**CITY OF TEMPE  
DEVELOPMENT REVIEW COMMISSION**

**Meeting Date: October 23, 2018  
Agenda Item: 3**

**ACTION:** Request a Development Plan Review for a new office warehouse building consisting of three suites within a 6,000 square foot building for APACHE TAXI, located at 820 North McClintock Drive. The applicant is Apache Taxi, LLC.

DPR180122 Development Plan Review including site plan, building elevations, and landscape plan

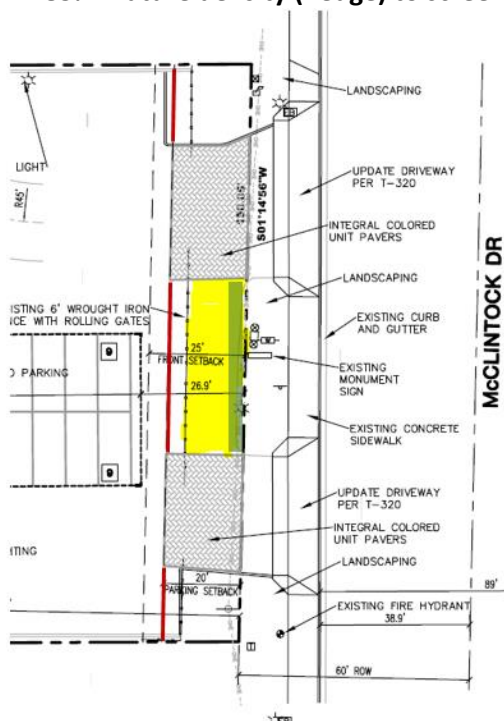
2. **Street front improvements shall include:**
  - a. **Provide upgraded paving at each driveway consisting of integral colored unit paving. Extend this paving in the driveway from the right-of-way line to 20'-0" on site and from curb to curb at the drive edges. From sidewalk to right-of-way line, extend concrete paving to match sidewalk.**

- b. **Provide 3' tall masonry screen walls at the 20' parking setback to screen vehicles on site and prevent parking in the 20' setback (red lines on illustration below indicate required screen walls).**

- c. **There shall be no vehicle parking or display east of the fence per prior conditions of DR-71.109 (April 19, 1978) and DR-88.54 (March 2, 1988); this area is provided for safe forward movement to the public street when gates are closed. This asphalt area (shown in yellow on the illustration below) is not to be used when gates are open.**

- d. **If parking, or vehicle display occurs within the 20' setback, the existing fence and gates shall be relocated out of the front yard setback, circulation will be required to occur outside of the front yard setback and the current asphalt shall be removed and replaced with landscape per the prior condition #4 DR-88.54 (March 2, 1988).**

- e. **Gates shall remain open during business hours of all businesses on site.**
  - f. **Remove 4' wide strip of asphalt and replace with landscape material west of the ROW line (shown in green on illustration below). Landscape to including plants that are 3' tall, with an 85% mature density (hedge) to screen the turn-around from view.**
